Appendix I of RNTPC
Paper No. A/YL-KTN/994A

**APPLICATION FOR PERMISSION
UNDER SECTION 16 OF
THE TOWN PLANNING ORDINANCE
(CAP. 131)**

(a) Proposed use(s)/development 擬議用途/發展	Proposed Temporary Open Storage of Construction Materials for a Period of 3 Years and Associated Filling of Land (Please illustrate the details of the proposal on a layout plan) (請用平面圖說明擬議詳情)

(S.16 Planning Application No. A/YL-KTN/994)

- End of Text -

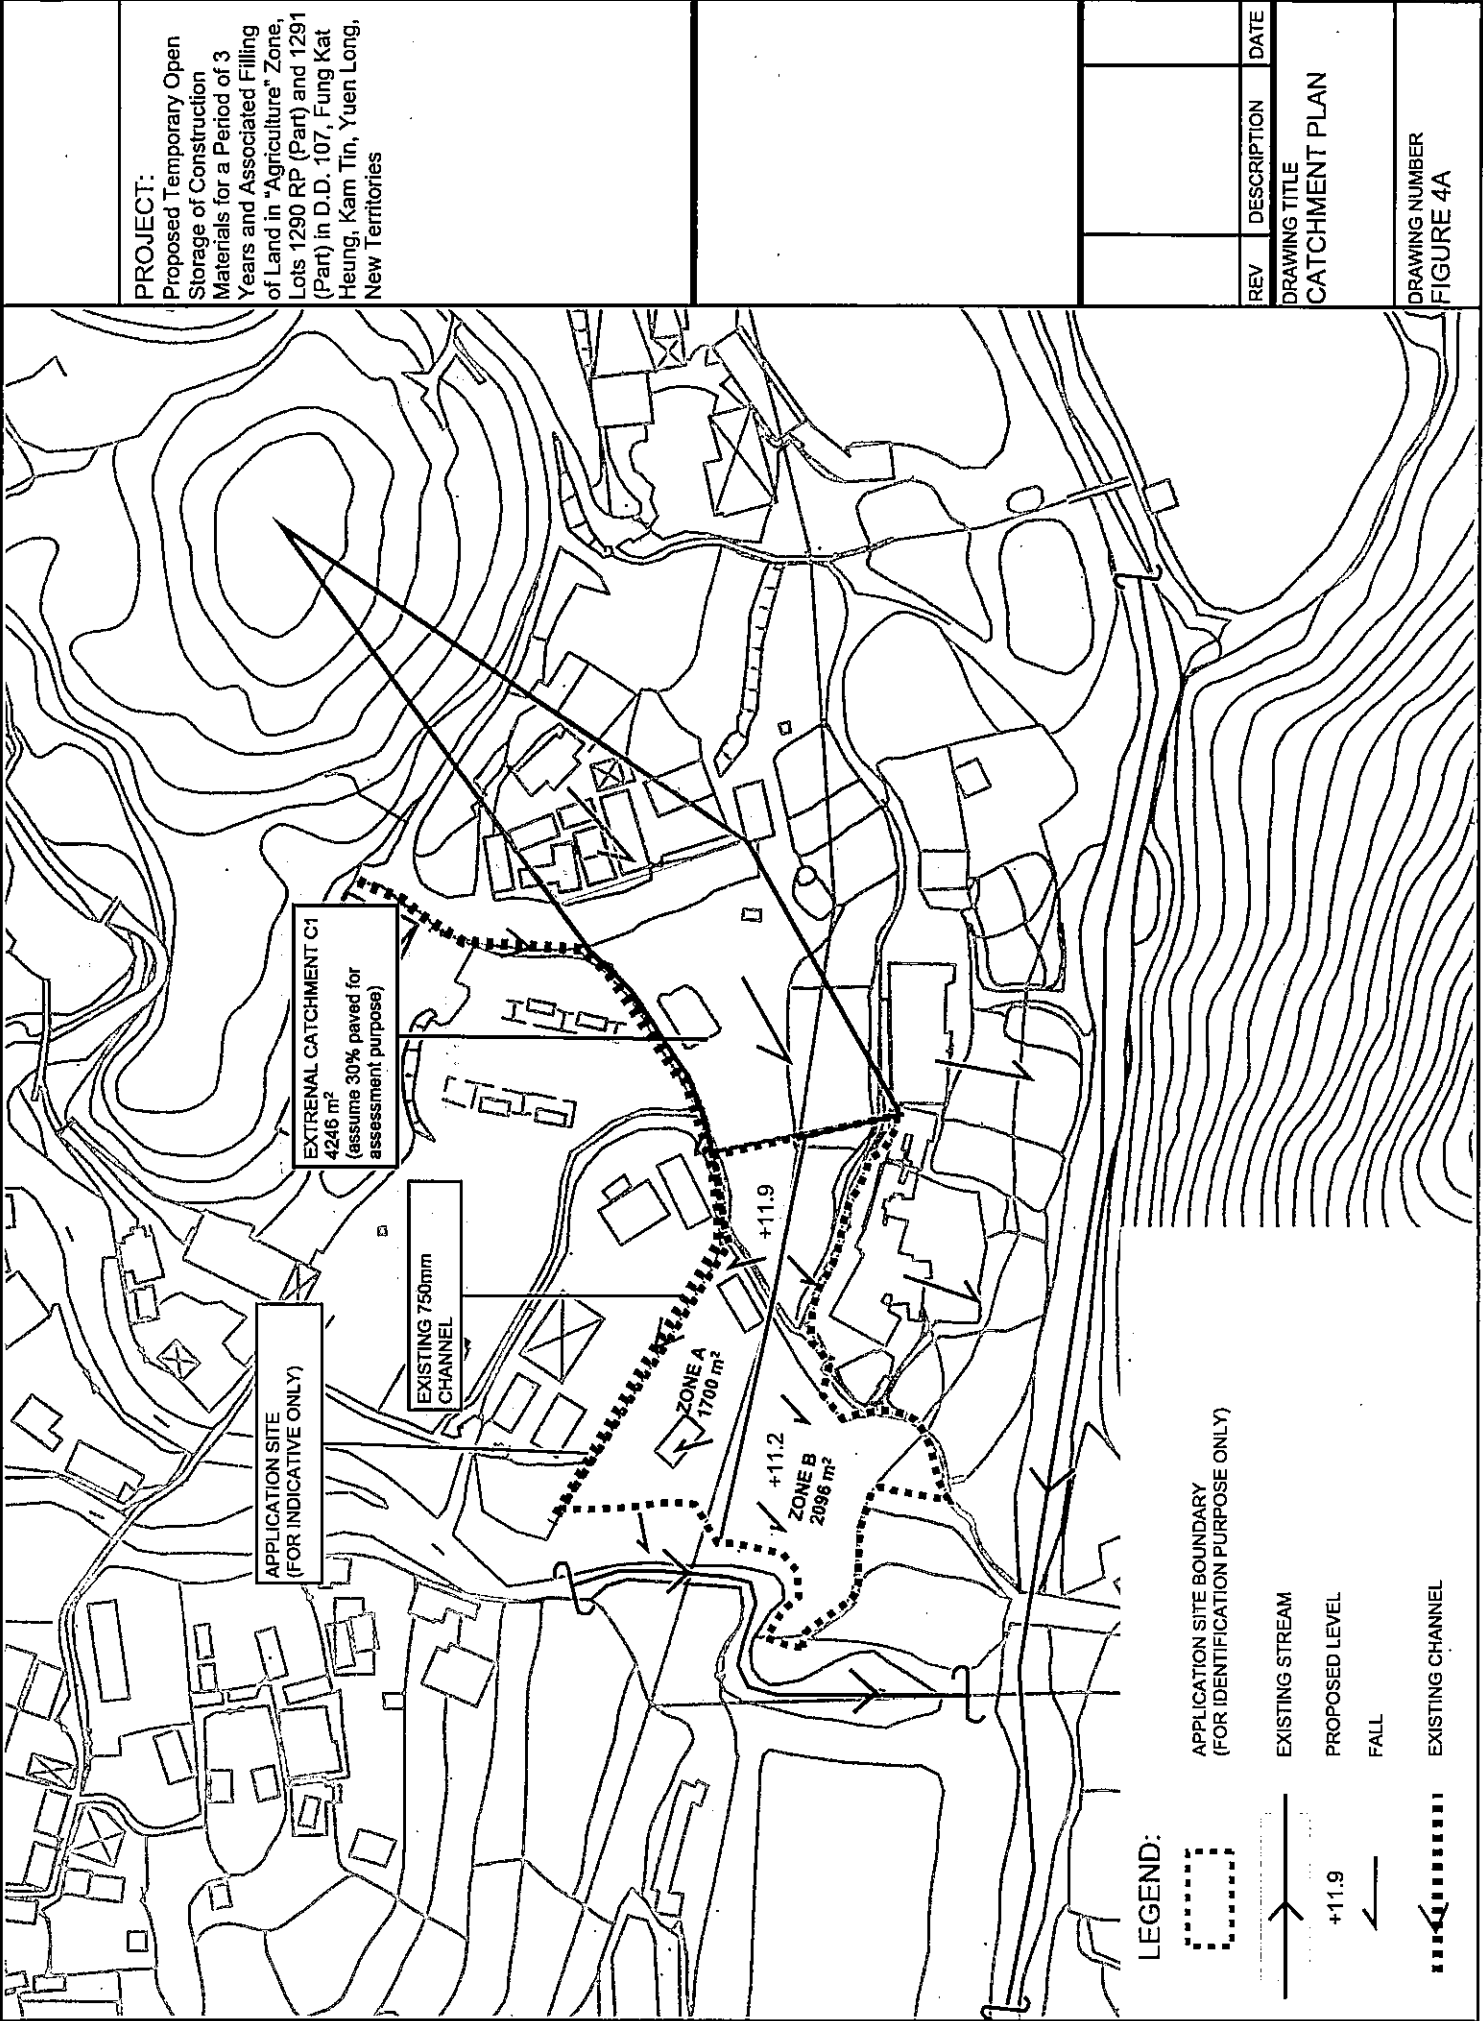
(a)	Please review and revise the proposed external catchment area as it appears should be larger according to existing topographical data.	Noted. Please refer to the updated catchment plan in Figure 4 of Annex I .

(b)	Please number the proposed catchpits as CP1, CP2...etc. for reference.	Noted. Please refer to the updated Figure 3 of Annex I .
(c)	The invert level of last catchpit should be higher than that of existing stream.	Noted. Please refer to the updated Figure 3 of Annex I .

(d)	The proposal should indicate how the runoff (the flow direction) within the site would be discharged to the proposed u-channel.	Noted. Please refer to the updated catchment plan in Figure 4 of Annex I .

Figure 1 The application site (marked in red) is very close to the conservation area zone

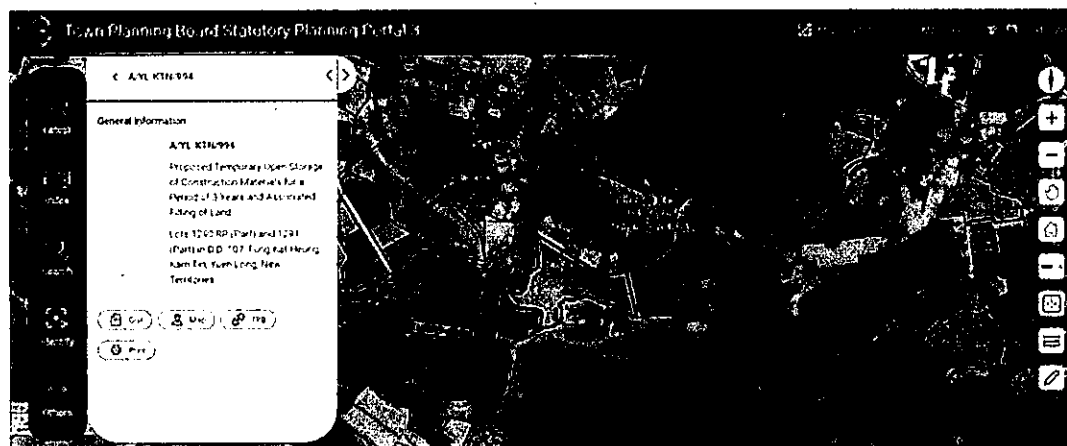
- Potential adverse drainage impact: we worry that the proposed land filling activity would largely change the hydrology of the site, and such change would not only affect the adjacent conservation area zone but also village settlement and other temporary uses.
- Other sources of environmental impacts not clearly addressed: We found that the application site is very close to the conservation area zone (Figure 1), it is worried that the indirect impact such as noise pollution will be made by the truck while transporting the construction materials.
